NINE MILE POINT NUCLEAR STATION, UNIT NO. 1

Amendment No. 13
License No. DPR-63

Amendment No. 12
License No. DPR-63

ATTACHMENT TO LICENSE AMENDMENT NO. 12

Figure 3.1.7.f

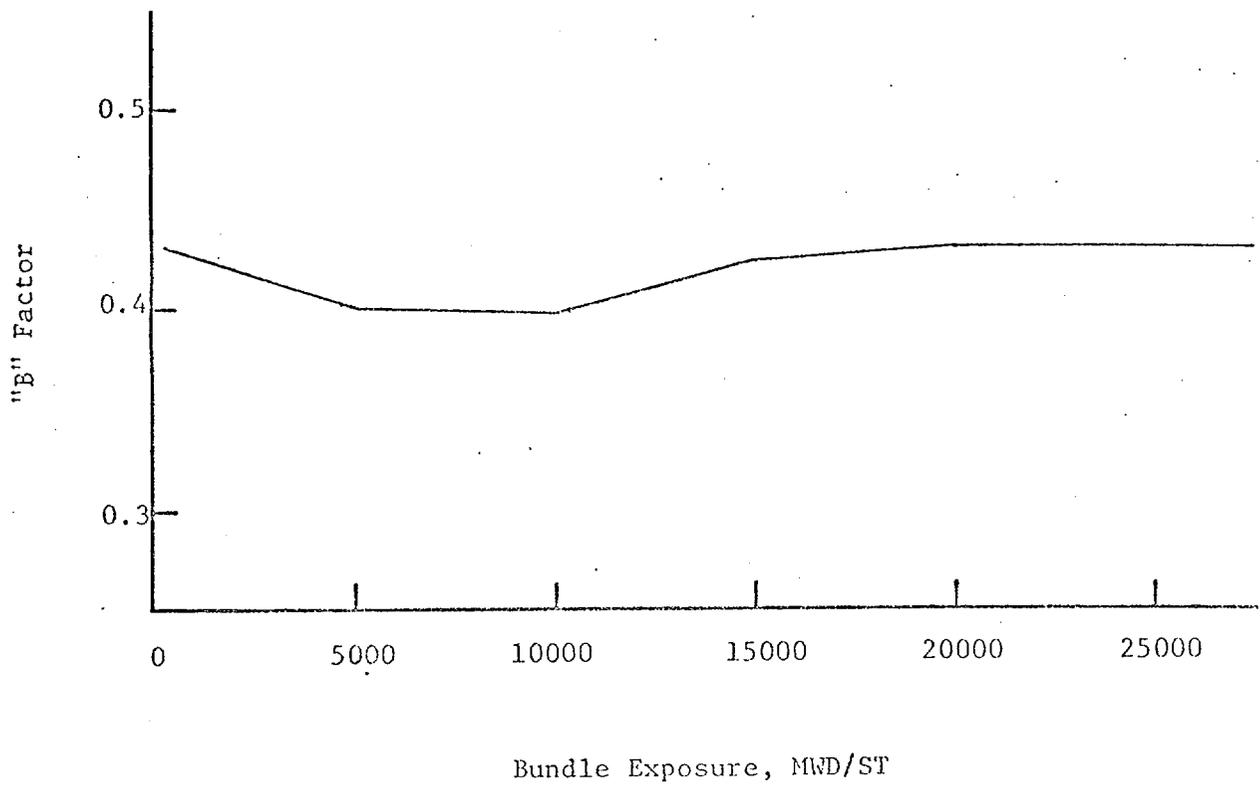
<u>Fuel Type(s)</u>	<u>"B"</u>
Type 1 - initial core	Figure 3.1.7.f
Type 2 - reload 1	Figure 3.1.7.g
Type 3 - reload 2	Figure 3.1.7.h
Type 4 - reload 3	Figure 3.1.7.i
Type 5 - reload 4 (2.50 enrichment) and reload 5	Figure 3.1.7.j
Type 6 - reload 4 (2.62 enrichment)	Figure 3.1.7.k
